# ADA Curb Ramp New Construction Inspection Form (Combination)

Nw 287

24952.54

Nw mays

COMBINATION RAMP (C)

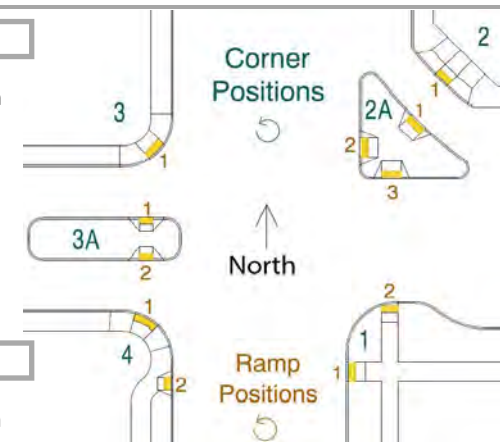
IITD RR1 fail
